Kirby Morgan Dive Systems, Inc.®

Change to Product, Bulletin 7 of 2006 November 1, 2006 Helmet Sealed Pull Pins (Part #505-110) No Longer Marked with an "S"

New sealed pull pins will no longer be stamped with an "S."

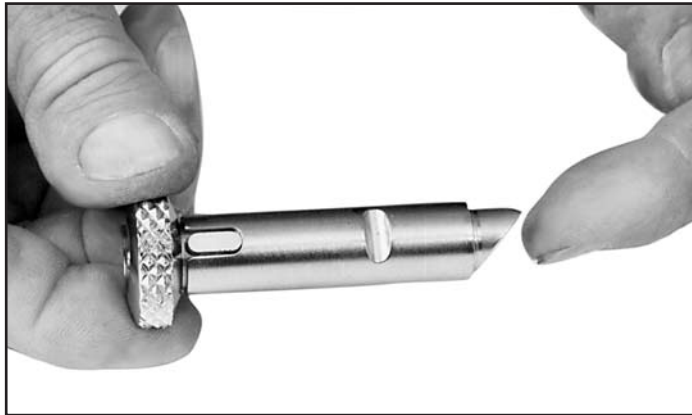
Effective October 30, 2006, all new Kirby Morgan helmets that utilize the locking collar design will be shipped with sealed pull pins (Part #505-110) that no longer have the "S" stamp on the body of the pin. This stamp was originally used to identify the current version of the sealed pull pin that used a silicone o-ring. Older pins did not have this stamp (or silicone o-rings), (Reference Bulletin 1/95 - February 1995).

Except for a few kits still in our stock, replacement sealed pull pins ordered today will not longer have the "S" stamped on the body of the pin.
